MIAMI BEACH

Staff Report & Recommendation

Design Review Board

SUBJECT: DRB19-0424
6948-6988 Abbott Avenue and 6957-6965 Byron Avenue

Northeast corner of project with steps and ramp

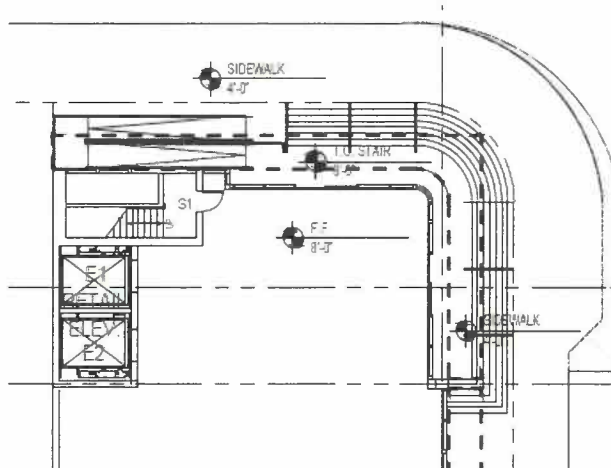
This design option eliminates the required 10'-0" wide sidewalk "pedestrian path" free of obstructions to facilitate pedestrian circulation at the corner. This design proposal not only reduces the sidewalk, but also the available area is pushed closer to the street which could result in a safety hazard for the public. In addition, the planters proposed also interfere with the required clearances. Staff also has concerns with the relocation of the utility pole and cabinet on the sidewalk, as the applicant has not provided any information in regards to the relocation of these elements.

In order to address future issues of flooding, the applicant has proposed to locate the interior elevation of the ground floor at base flood elevation. However, the manner of access proposed by the applicant, which is a design choice, does not comply with the requirements of the Land Development Regulations of the City Code. The applicant is seeking variances to address this non-compliance with the applicable requirements of the LDR's.

Staff believes that there is no practical difficulty of hardship associated with these variance requests, as access to the interior can be provided in a code compliant manner. For instance, by increasing the building setbacks to allow the stairs to be recessed into the property and not adjacent to the public right of way, the variances could be eliminated. Another option would be to lower the elevation of the ground level, and utilize internal flood barrier protection. As noted on page X1.1 of the plans (below), reducing the elevation of the ground floor, as originally proposed, is technically feasible.

Staff believes that the interior elevation can be successfully elevated, provided the building access points are recessed, either at the corner location or another location. Such a recess would accommodate entrance steps, as well as an accessible ramp in an equitable, covered manner. Alternatively, these access points could occur interior to the building envelope. In summary, due to the negative impacts of the requested variances and the incompatibility with the practical difficulties criteria, staff recommends denial with prejudice of both variance requests.

Current submittal, view along Paseo south façade

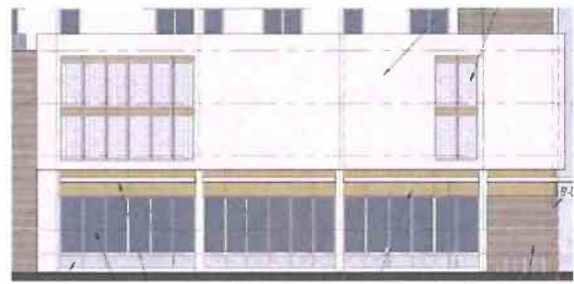
The proposal still lacks a detailed plan that identifies all the public space elements that include seating, special paving, landscaping, and pedestrian scaled lighting to create usable public spaces. The architect has also wrapped the ground level of the south façade that forms the “Paseo”, the planned midblock passage in the similar architectural language of the Abbott Avenue façade.

Additionally, since the completion of the full street paseo is not possible at this time, the proposed design results in a dead-end street that as a basic CPTED strategy should be avoided in all instances. As such, until that time when a full passage is finally realized through the development of the western parcel, staff would recommend the architect provide elements to block off the dead-end spaces with a well-designed and articulated transparent fence or gate system to limit access during portions of the non- business hours / evening.

- h. The architect shall provide additional design details / further refinement of the ground retail tenant build out along the paseo. Additionally, a detailed plan that identifies all the public space elements that include seating, special paving, landscaping, and pedestrian scaled lighting to create usable public spaces shall be provided for staff review.

- i. The architect shall provide elements to block off the dead-end spaces with a well-designed and articulated transparent fence or gate system to limit access during portions of the non- business hours / evening along the paseo.

Current submittal, 71st Street façade (north elevation)

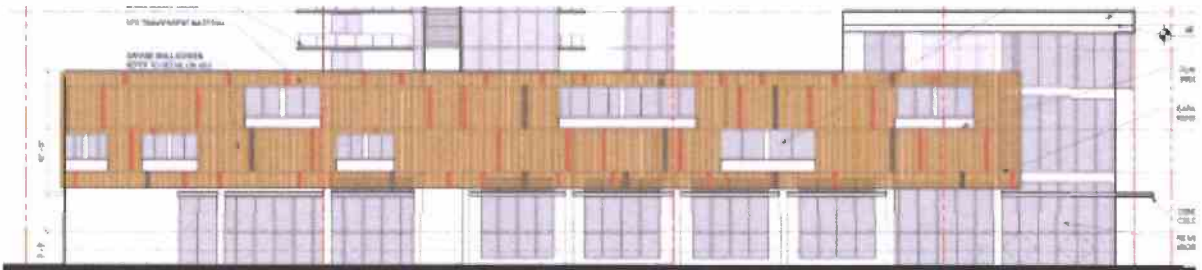
Whereas staff's concern with the design in previous iterations pertained to the blank zero-lot-line elevations facing 71st Street, the current design has addressed such concerns. The zero-lot-line elevations facing both the north (71st Street) and south (internal) elevations, inclusive of the 55' high wall behind the existing surface parking lot and one-story restaurant that extends 175'-0" eastward from Byron Avenue, have been redesigned to incorporate green landscape screens at the ground floor adjacent to the parking lot, and geometric patterned metal screens contrasted with ribbed stucco at the upper levels, providing significant movement and interest to otherwise expansive walls that face public right-of-way.

Current submittal, view along Abbott Avenue façade

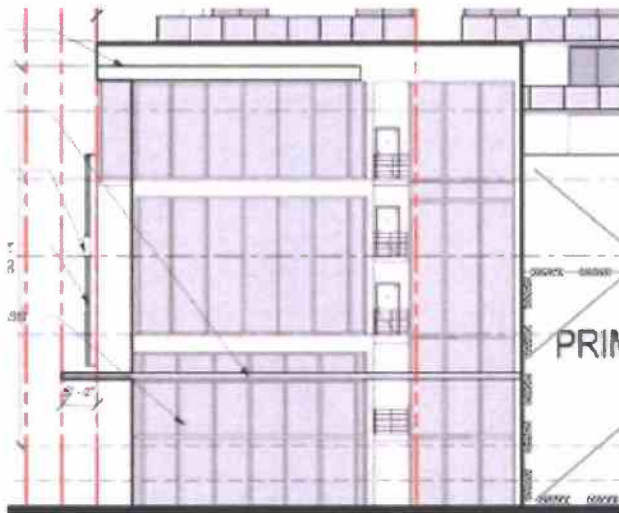
The architectural design of the east and west facades of the second and third floor parking and residential liners along Byron Avenue and Abbott Avenue have also been revised. The garage screening along Abbott Avenue has been significantly redesigned in such a manner that it directly relates to the architecture of the proposed retail that rounds the corner at 71st Street yet has its own distinct identity. Picking up the horizontal movement of the stucco bands that outline the glazing of the four-story corner/retail volume, stucco frame at levels two and three projects beyond the glazed retail wall of the ground floor and inlaid with a grid of textured metal screens that contrast with verticals band of ribbed stucco. Furthermore, the stucco frames are broken up just past midpoint by a four-story green landscape screen that climbs and aligns with a vertical glazing band of the residential tower. Whereas the residential liner along Abbott Avenue has been redesigned to integrate a similar stucco frame that is accented by vertical champagne-colored metal fins and within which a recessed glazing walls are accented with Juliet balconies of geometric textured screening.

Similar to the concerns expressed by the Planning Board, staff has additional concerns with some aspects of the design that have yet to be fully realized with this revised set, specifically on the transparency of the stairwell on the north elevation (along 71st Street). The revised stairwell elevation is much improved as it is encased in the champagne colored metal panels that are inset with the dynamic screening common throughout the project, yet at its ground floor the architect has fully concealed its landing and entrance. While the gold-toned composite

panels are alluring, staff recommends transparency at this level to better address this architectural element with the pedestrian realm. Additional concerns remain pertaining to the lack of detail from landscape and the amenity deck, with staff recommending further refinement of such vital components.

Current submittal, view along 71st Street façade

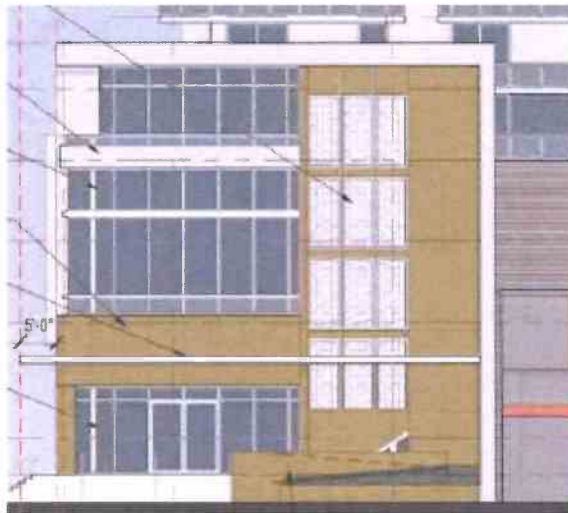
The applicant has indicated some exterior modifications to the proposed stair along 71st Street. As directed by the Board, the stair now appears to feature an open air design with colored vertical slats or fins. The unenclosed nature of the ground floor of the stair may encounter some challenges as it pertains to trash and refuse collection, safety concerns, protentional housing of vagrants, and general maintenance goals. Although the architect has begun to improve the stair, further refinement and details are necessary.

Within the most architecturally successful component of the project, the corner building at 71st Street and Abbott Avenue, a four-story stair tower is proposed along the 71st Street elevation. The submitted elevations do not correctly reflect the floor plans or rendering. On sheet A5.2, the design of the stair seems to be of an open nature, which staff highly supports. A prominent, visible, appealing and comfortable stair will encourage active use, and avoid another vertical blank wall along the TC-C's most vital and vibrant corridor. Staff recommends further refinement of the design of the open stair tower by incorporating architectural screening features that enhance and highlight the movement of the staircase as it rises.
